**Service Contract No. NDO 04/2019**  
**Environmental Team for Environmental Monitoring and Audit Works in Construction Phase for the First Phase Development of Kwu Tung North and Fanling North New Development Areas**

**Environmental Permit No. EP-469/2013: Submission of the Landscape Plan for Sewage Pumping Station D1-3 (Condition 2.6)**

**Submission of Landscape Plan for Sewage Pumping Station D1-3 (EP-469/2013)**

(Ref. EP/DP5/D1-3/2022-01A)

**SHEET TITLE**  
 COMPENSATORY PLANTING PLAN

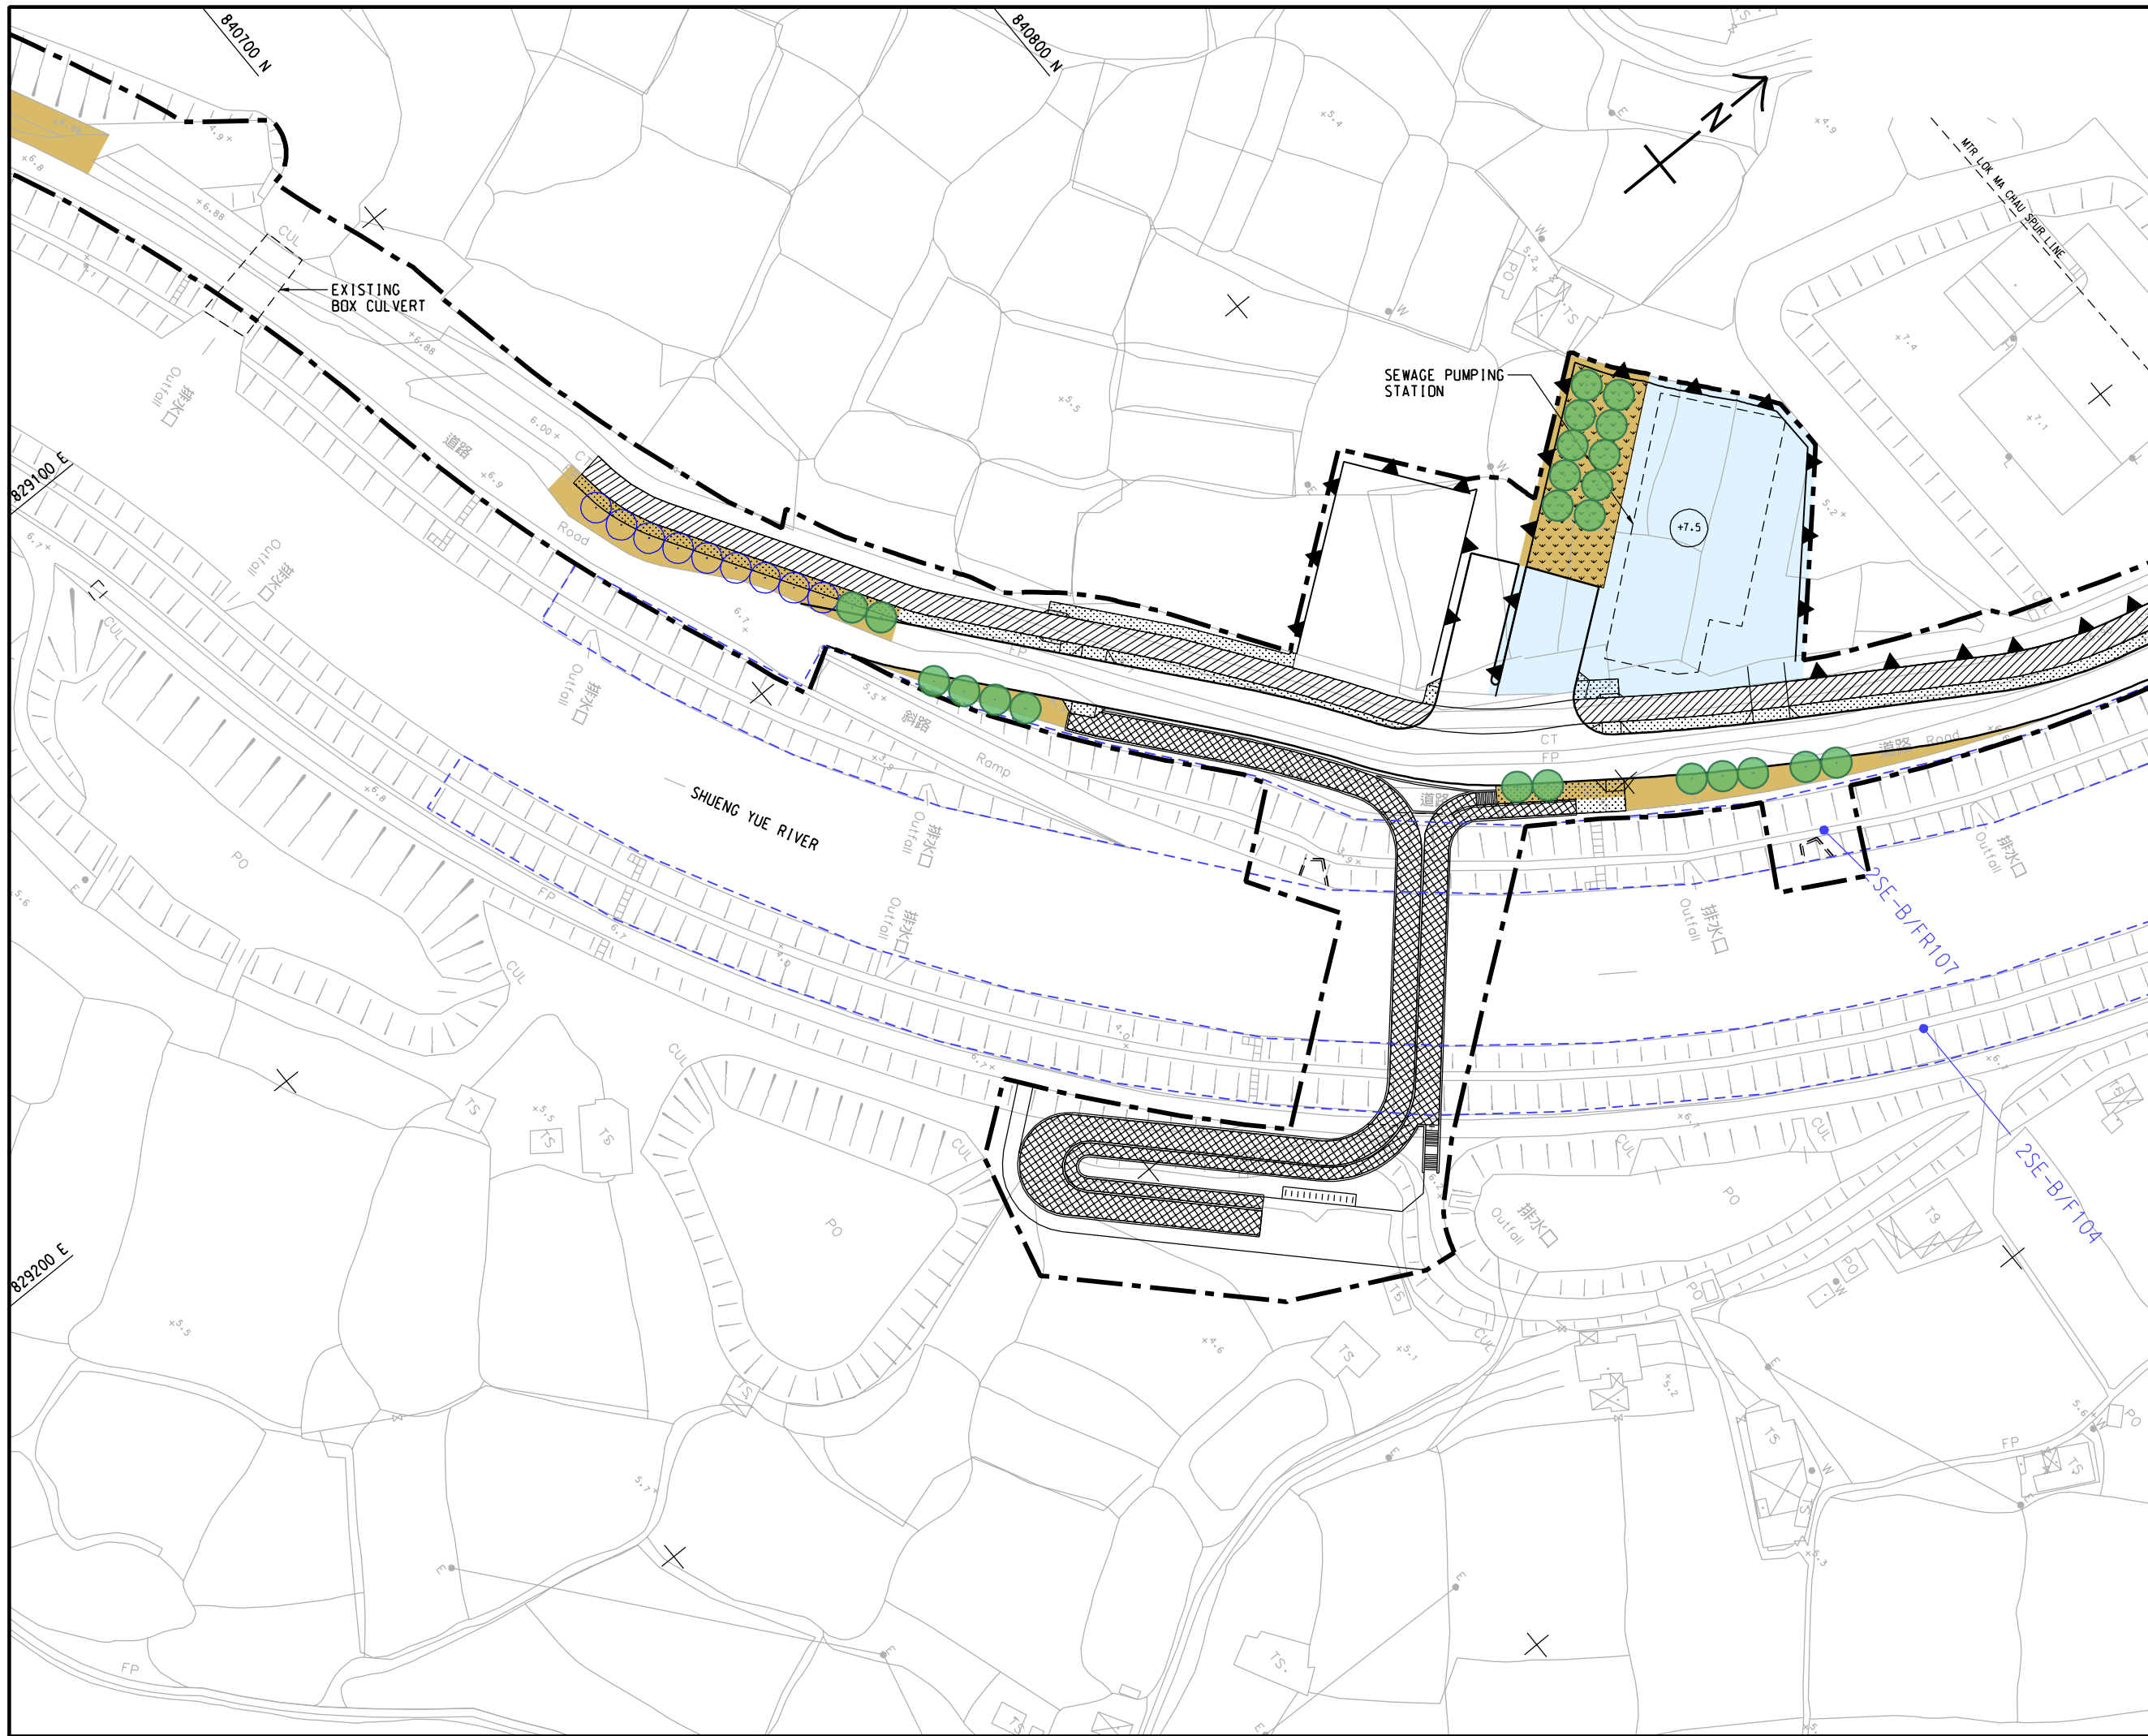
<p>(i) Para 5.7.1, please clarify when and by which approving authority the compensatory planting proposal has been approved. Compensatory planting plan for compensatory trees to be planted outside SPS D1-3 application site area should be provided</p>	<p>In accordance with the Report para. 5.11 and Appendix III Proposed Species – Trees, total 9 numbers of trees are proposed to be planted within the SPS D1-3 area as compensatory tree planting which has been included in the conforming design from Drainage Services Department dated November 2019.</p> <p>Location of the remaining 23 numbers of approved fell tree outside SPS D1-3 application site area should refer to the approved Tree Preservation and Removal Proposal (Master TPRP) reference no.:C03-04 under the LandsD approval letter reference no. (31) in LD NDA/PD/2/2 dated 25 January 2019. The compensatory planting plan is extracted in Appendix IV – Compensatory Plan and 23 no. of compensatory planting are identified as shown in the drawing.</p>

5.7.4 The remaining 23 no. of compensatory trees will be planted adjacent to the SPS D1-3 area within amenity area and as streetscape. Retrieved the compensatory tree plan from the approved TPRP (reference no. C03-04) under the LandsD approval letter reference no. (31) in LD NDA/PD/2/2 dated 25 January 2019 for the Phase 1 project, the location of remaining 23 no. of trees are identified. Location of the trees can refer to **Appendix V** for ease of reference.
